Subject: POPPING AND/OR SQUEAKING NOISE FROM FRONT SHOCK ABSORBER	Bulletin No: 02-004/15
	Last Issued: 04/24/2015

2014-2015 Mazda3 vehicles (Japan built) with VINs starting with JM1

2014-2015 Mazda3 vehicles (Mexico built) with VINs starting with 3MZ

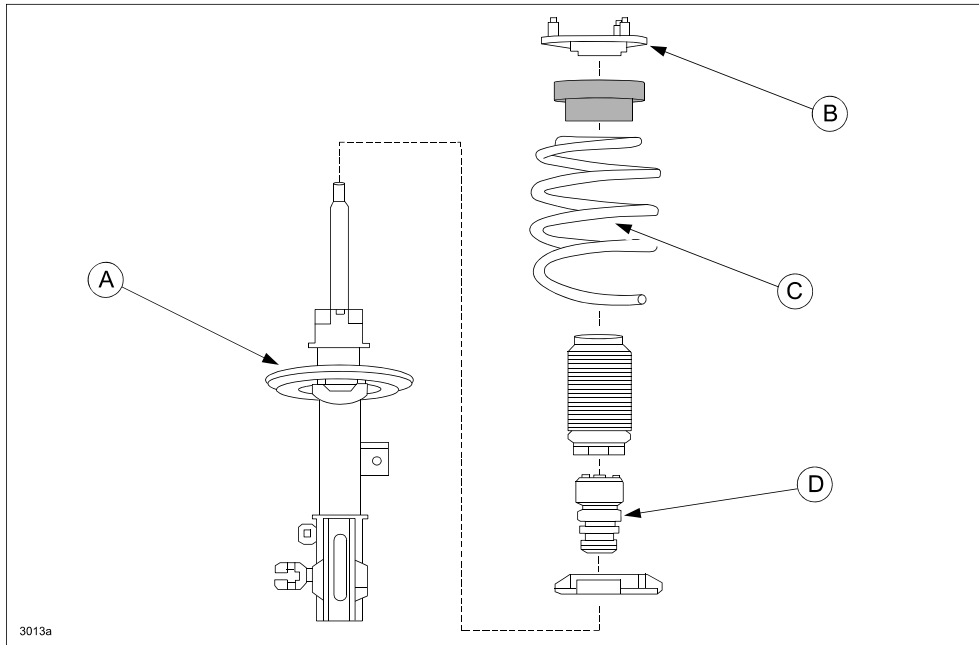
To correct the problem, the shape of the bump stopper has been modified and a protector has been installed onto the coil spring.

3013a

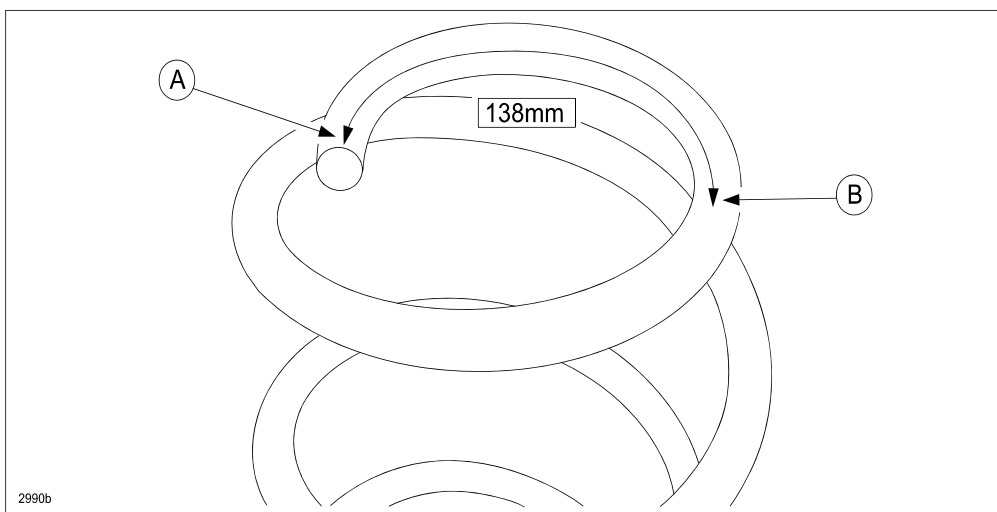
1. Verify the customer concern of noise coming from the upper part of the shock absorber when turning the steering wheel and/or driving over bumps.
2. Replace the bump stopper with the modified one according to MS3 online instructions or the Workshop Manual (section 02-13 FRONT SHOCK ABSORBER AND COIL SPRING DISASSEMBLY/ASSEMBLY).

NOTE: Before removing the mounting rubber, mark its original position so it can be re-installed later to the same position.

CAUTION: It is not necessary to adjust the front wheel alignment because the front shock absorber and mounting rubber are not being replaced. However, make sure to install the mounting rubber to the original position.

2990b

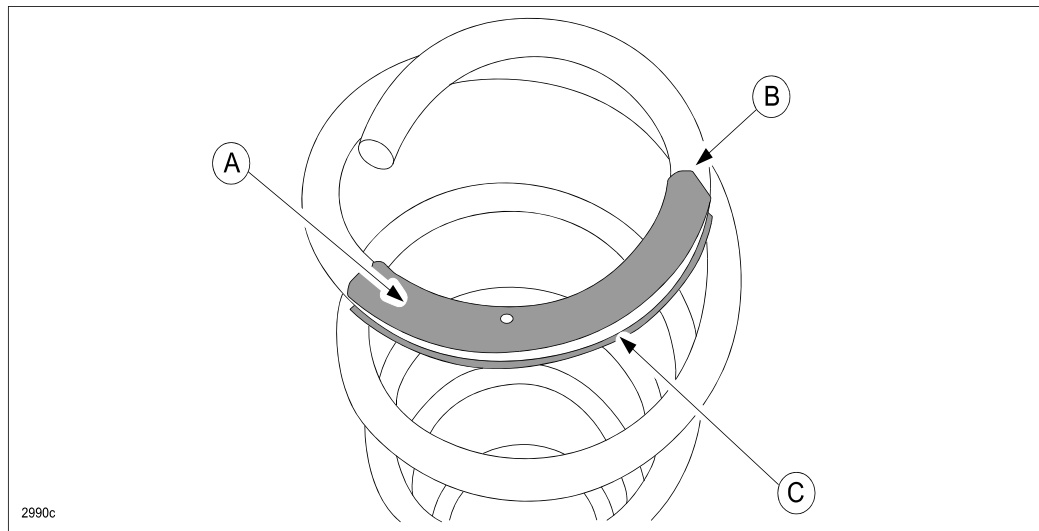
3. Install the protector onto the coil spring.
 - a. Degrease 1.5 turns of the spring from the top.
 - b. Cut a thin strip of paper to 138 mm in length (or use a cloth type measuring tape).
 - c. Place the strip of paper (or cloth measuring tape) along the inner side of the coil spring starting at point (A).
 - d. Mark the spot on the spring where (B) is. (B) is the starting point for the protector installation.

- e. Install the protector (A) onto the coil spring aligning the end (slant cut side) with the marking at spot (B).

NOTE: Install the protector so the gap (C) is evenly aligned around the outer edge of the coil spring.

- f. The inner side of the protector contains adhesive glue. After installing the protector onto the spring, press the inner side to firmly adhere it to the spring.
